DEVELOPMENT REVIEW BOARD MEETING

2. **Resolution No. 431. Citycounty Insurance Services (CIS) Oregon Collaboration Center.** The applicant is requesting approval of a Stage 2 Final Plan Modification, Site Design Review, Type C Tree Removal Plan, Class 3 Sign Permit and Waiver for development of a single story, 15,744 square foot, office building and associated site development on the southwest corner of Wilsonville Road and Kinsman Road.

**DEVELOPMENT REVIEW BOARD  
RESOLUTION NO. 431**

Exhibit A1  
Staff Report  
Wilsonville Planning Division  
CIS Oregon Collaboration Center  
Development Review Board Panel 'B'  
Quasi-Judicial Public Hearing

# CIS EXTERIOR MATERIAL BOARD

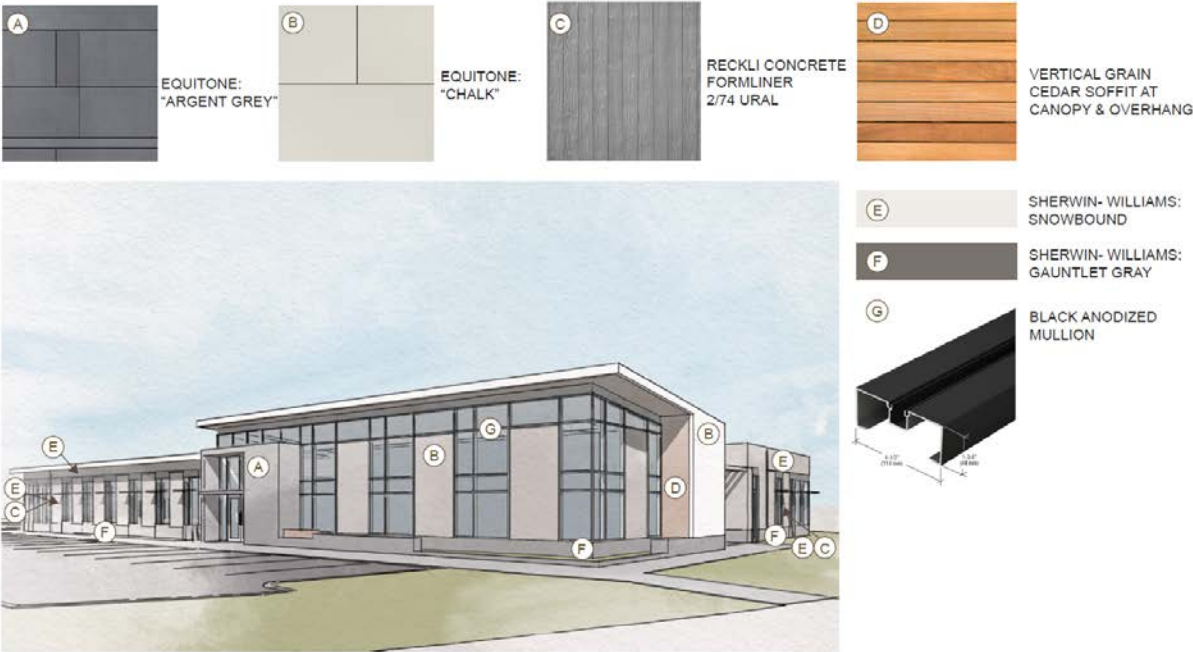
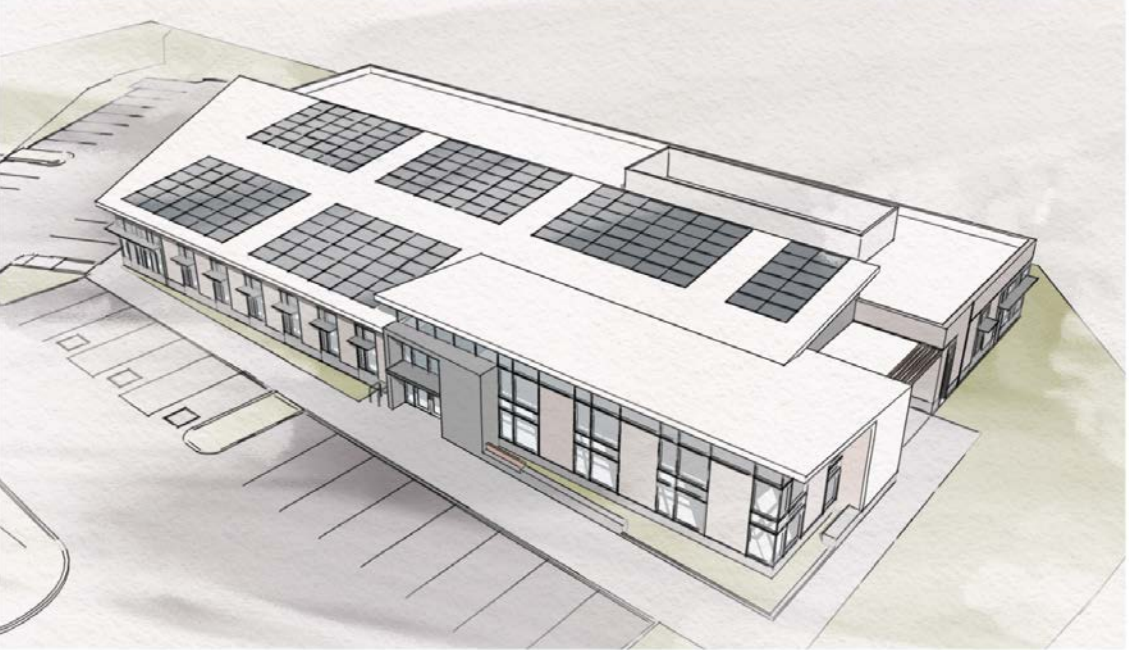
- B8.** The applicant used appropriate professional services to design the exterior of the building. Section 4.421 (.03) authorizes the Development Review Board to apply the objectives outlined in the purpose statement of Section 4.400 as additional criteria and standards for site design review. Significant amounts of glazing are provided on all facades of the building giving a lightness to the large building. An angular roof provides variation in height and interest creating a unique presence. The prominence of the proposed building along Wilsonville Road is carefully considered in the design on the building with a variation of material, articulation and ample glazing along the façade facing Wilsonville Road. Variations of grey and white are used throughout the façade with accents of cedar wood and black.
